Exhibit C Geotechnical Addendum

Re: Geotechnical Addendum Letter

Emerson Creek Wind Project – Karst Assessment T-25, T-26, T-42 and T-75

Erie and Huron Counties, Ohio RRC Project No. MD1901007

T-25

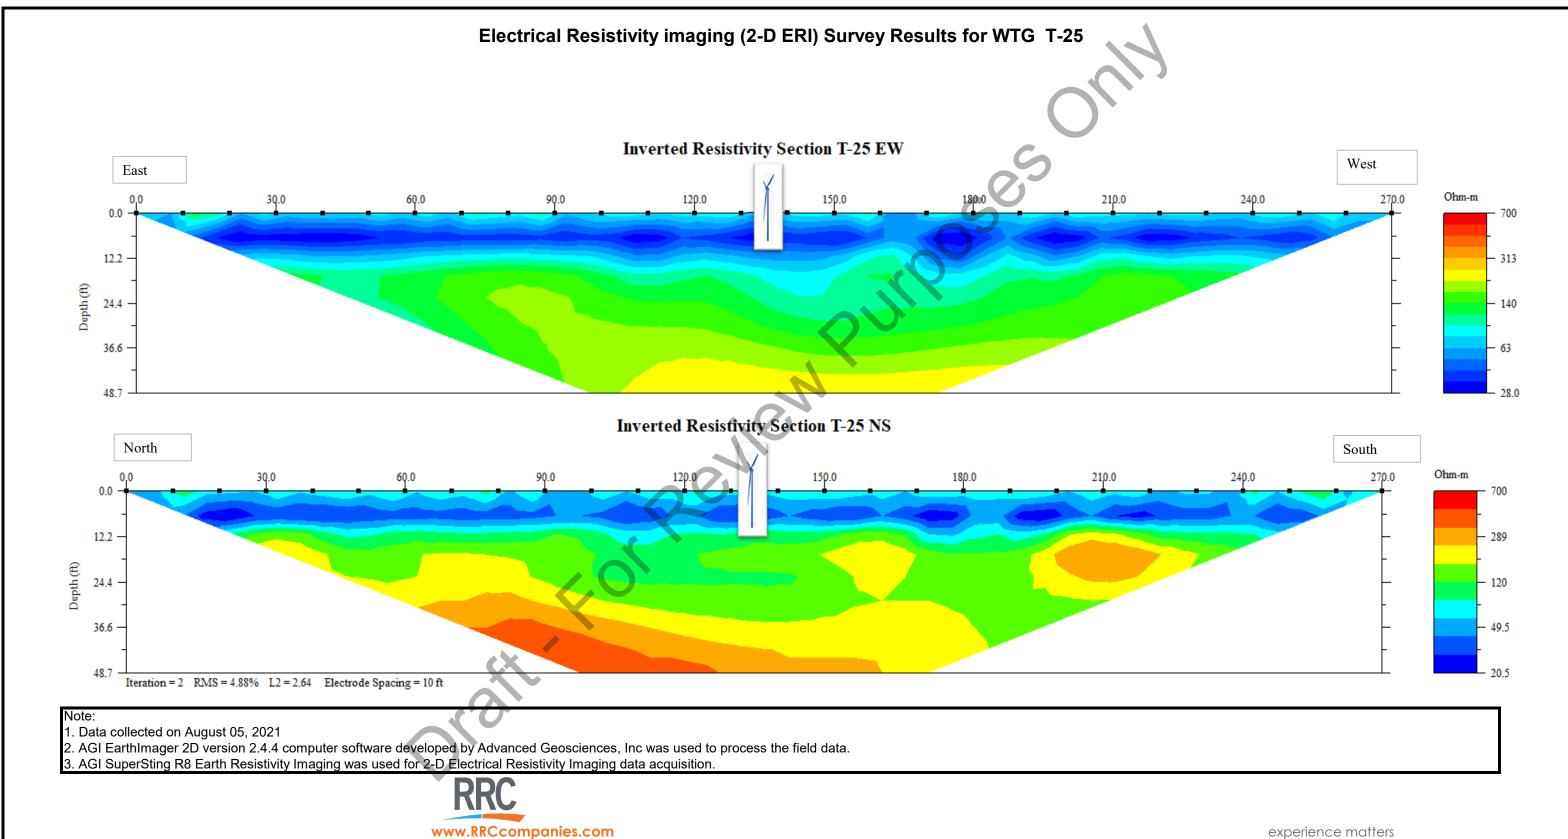
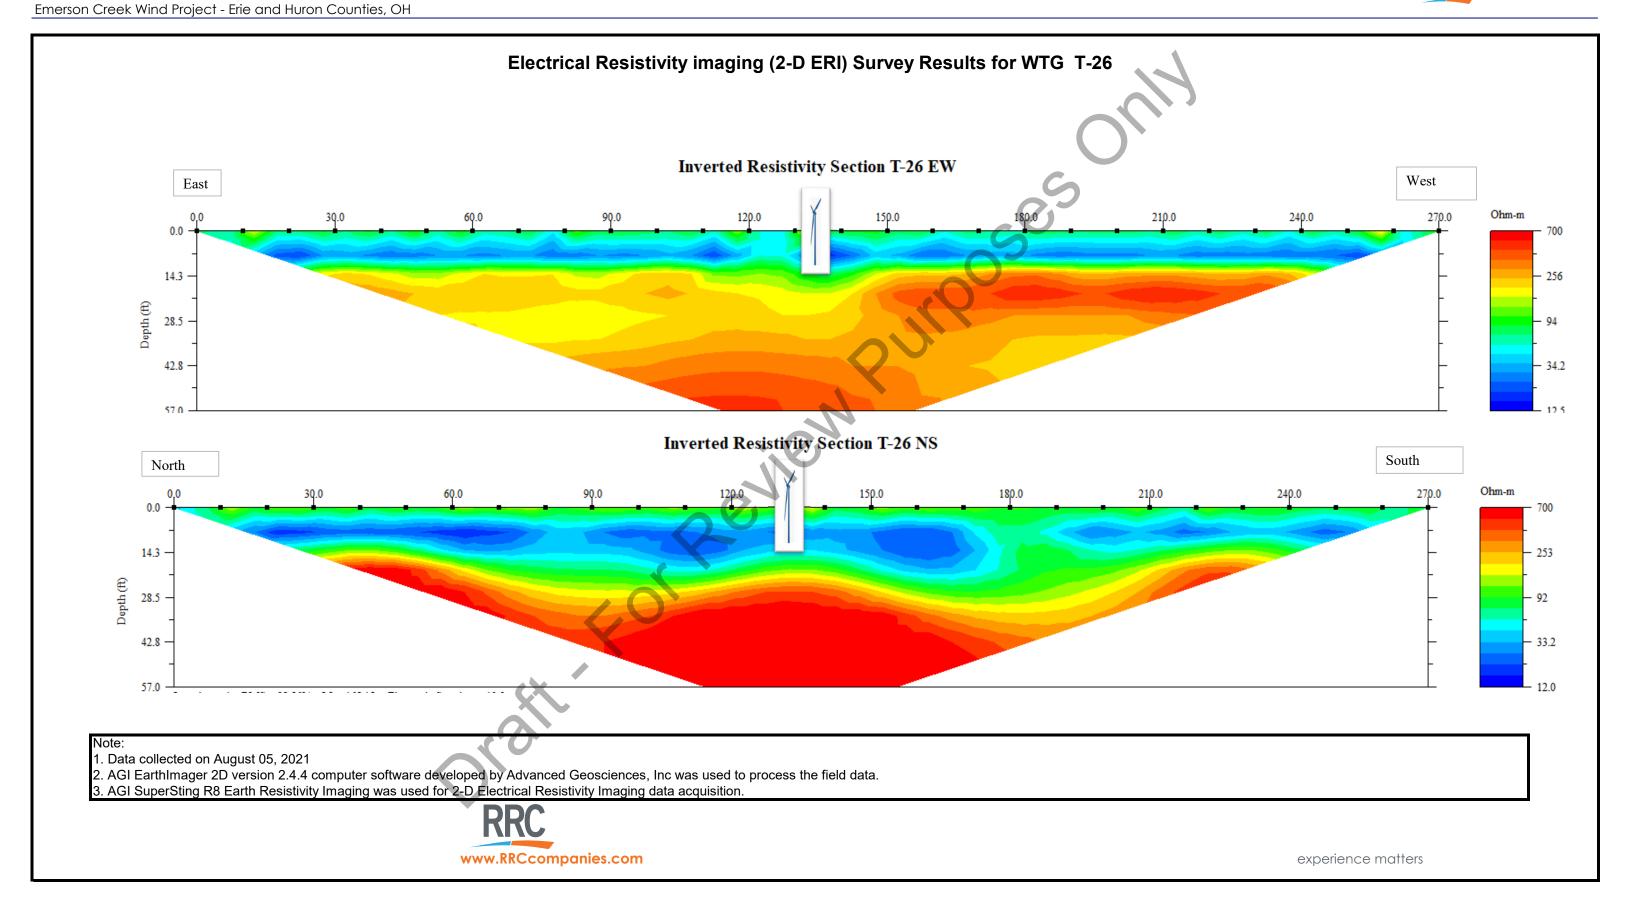
The ERI inversion model results for T-25 so no clear indication of large potential karst feature at the proposed tower location, although the elevated resistivity response on the N-S transect near station 210-ft S (\sim 70-ft south of tower) could indicate a karst related condition. The intermediate resistivity response (\sim 100-200 Ω -m) between approximately 10-ft to 30-ft could indicate a zone of greater bedrock weathering or karstification such as might occur in dispersed, small voids and dissolution features along with clay or water infilling within the shallowest limestone strata.

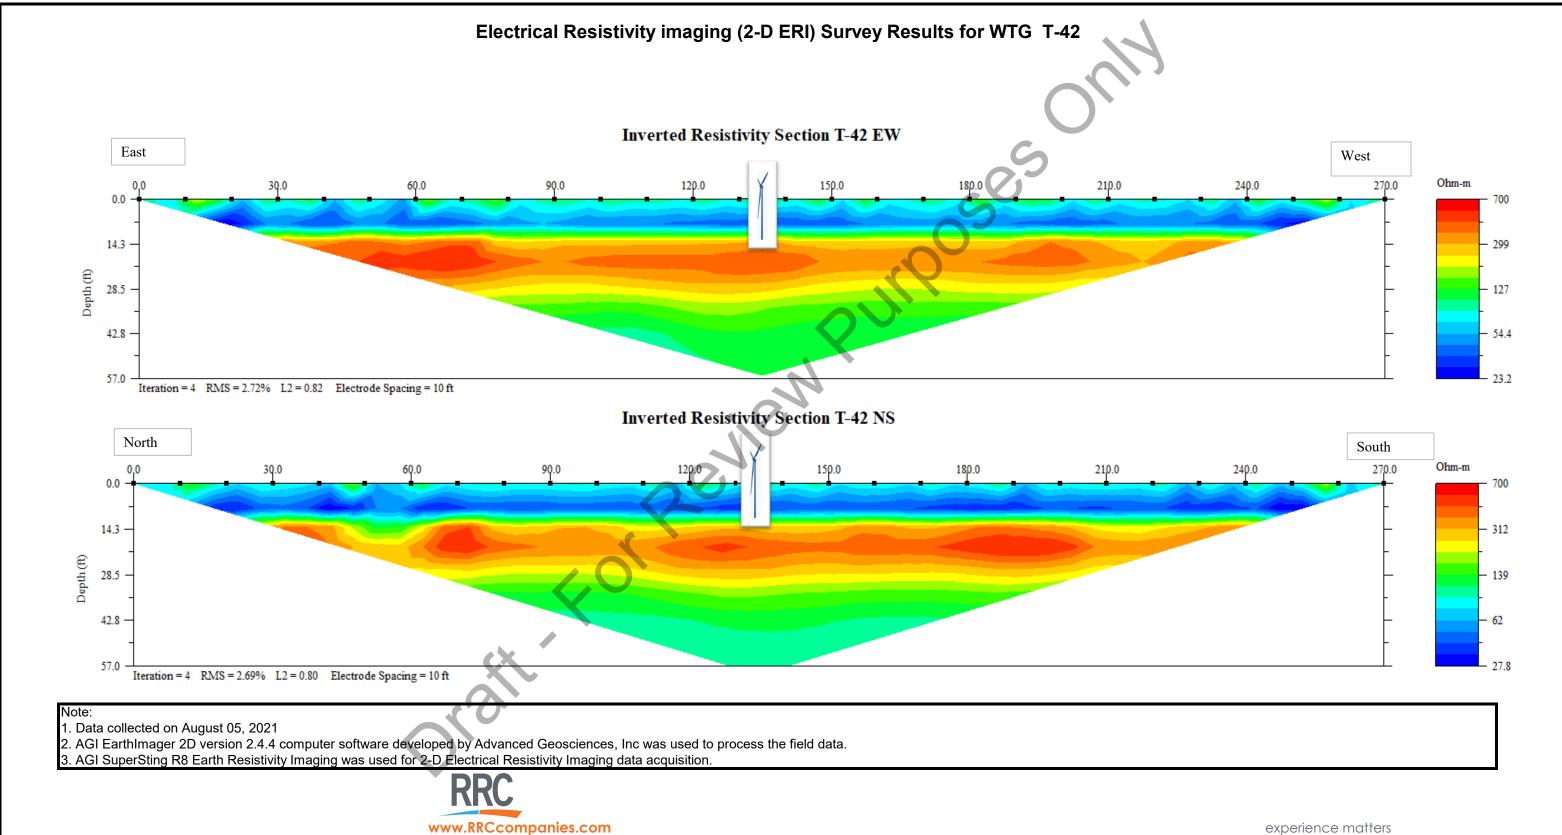
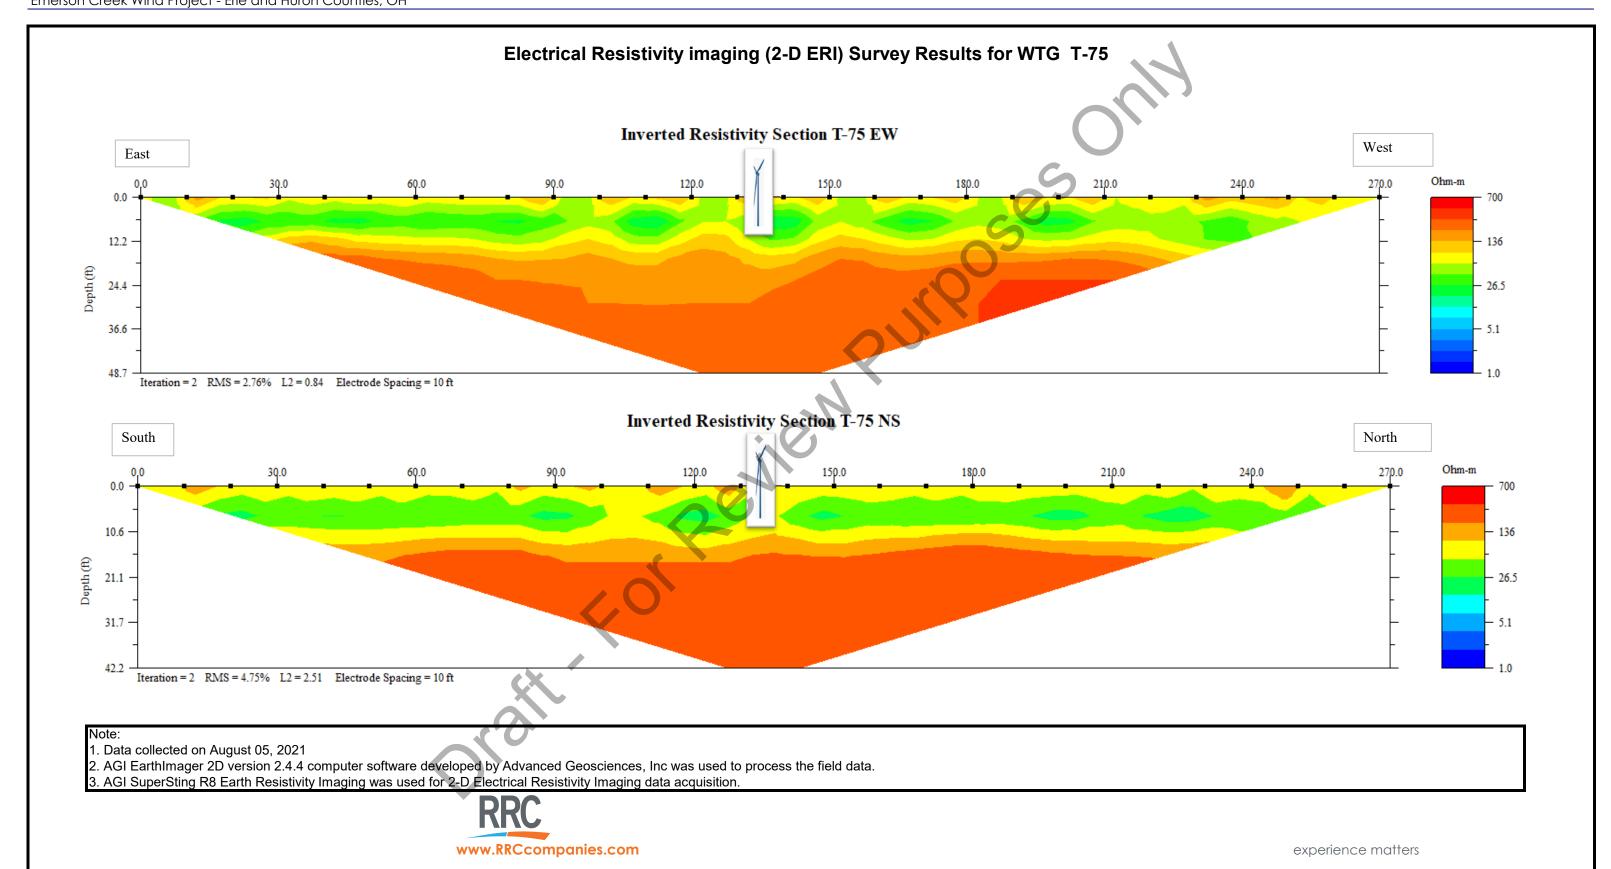
The ER inversion models indicate variation in the elevation and/or condition of the overburden-bedrock contact near T-26. Possible explanations include pre-glacial undulations in the bedrock surface, localized zones of deeper weathering, and/or minor karstification of the shallowest region of the limestone. The apparent difference in the resistivity levels between the E-W and N-W transects could point to a hidden linear feature (e.g. bedrock fracture/joints, drainage pipe, former fence line, etc.) in the vicinity of the test site. It is not clear why the E-W transect appears to show a deeper, gradational resistivity response below the tower location while the N-S shows a reasonably well-defined response for the overburden-bedrock boundary.
